| Company | Trenz Electronic GmbH |
| PCN Number | PCN-20201005 |
| Title | TE0710-02 DDR Change |
| Subject | BOM change |

2.1 #1 Change DDR Flash from IM4G08D3FABG-125 to IS43TR85120BL-125KBLI

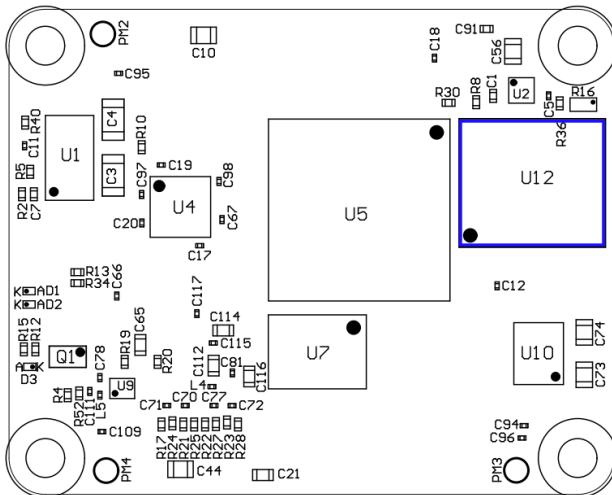
Type: BOM change

Reason: Old DDR was not specified for industrial temperature range.

Impact: New timings may be considered for existing designs.

Locate DDR (U12) at top side of PCB:

IM4G08D3FABG-125

IS43TR85120BL-125KBLI
